LINCOLN/LANCASTER COUNTY PLANNING COMMISSION STAFF REPORT

APPLICATION NUMBER
Special Permit #25039

PROPERTY ADDRESS/LOCATION
4200 SW 12th Street

CONDITIONS OF APPROVAL - SPECIAL PERMIT #25039

DESIGNER: AMELIA ZABELL
PROJECT: NEUKIRCH REMODEL
DATE: 8/13/2025
SHEET: 1 OF 8

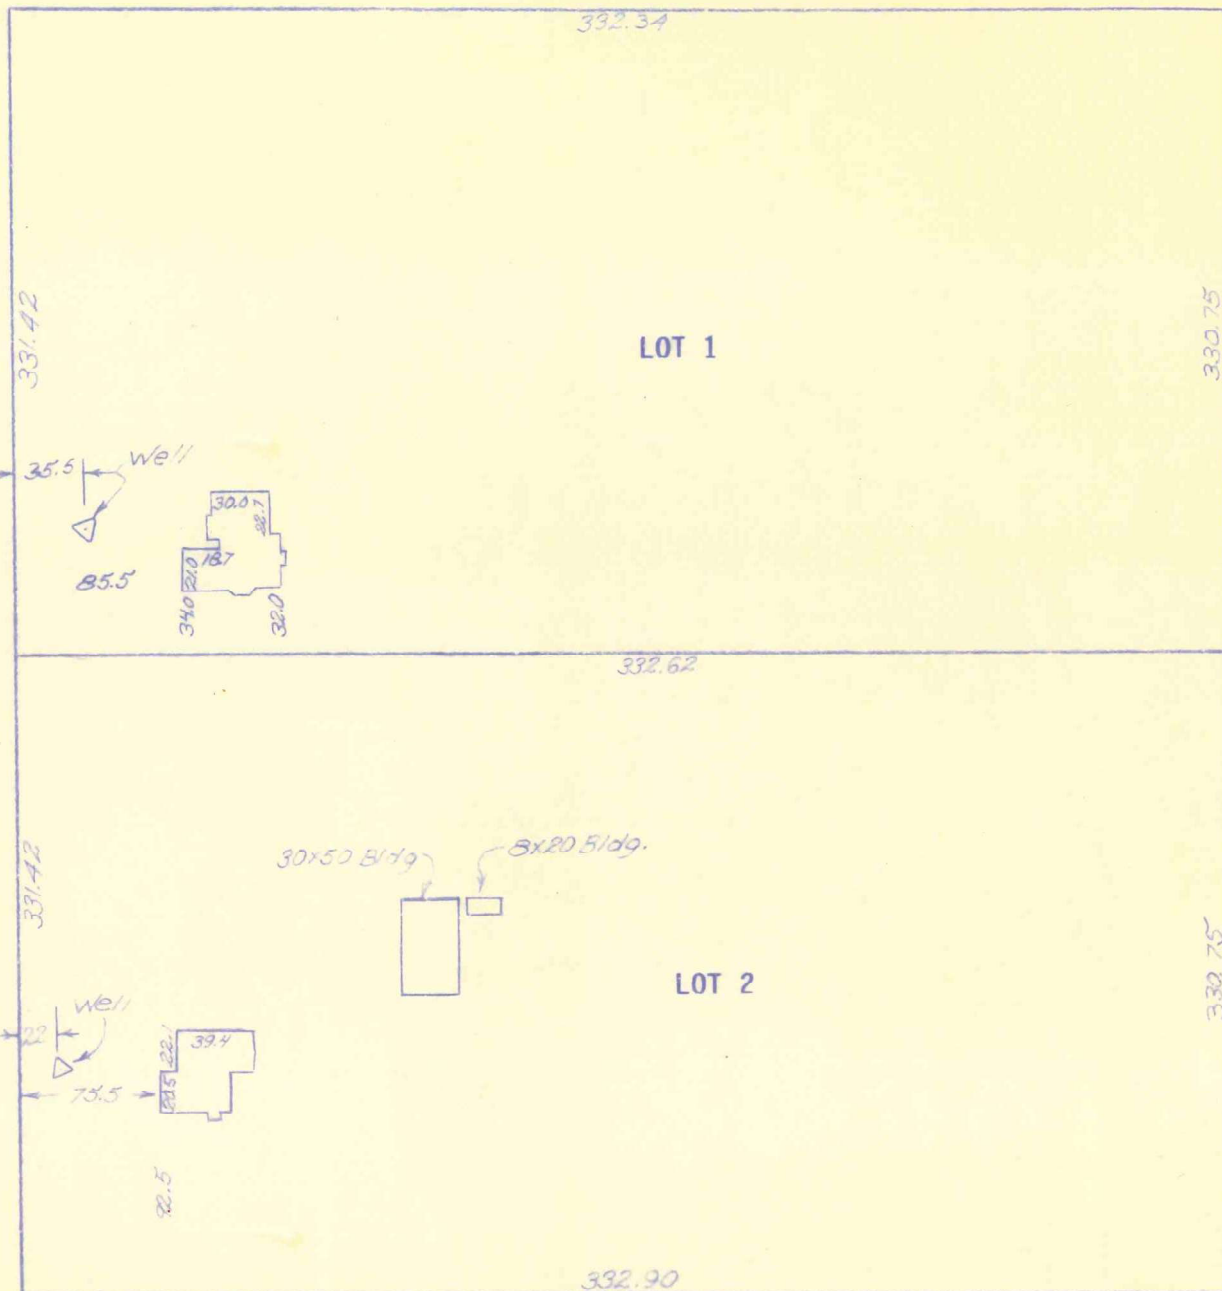
1. Before receiving building permits the permittee shall cause to be prepared and submitted to the Planning Department a revised and reproducible final plot plan including 2 copies with all required revisions and documents as listed below:
 - 2.1 Add the Special Permit number to the plan.
 - 2.2 Only include the first sheet (plot plan) for the Final Approved Plan.
 - 2.3 Revise rear yard setback to 100'.
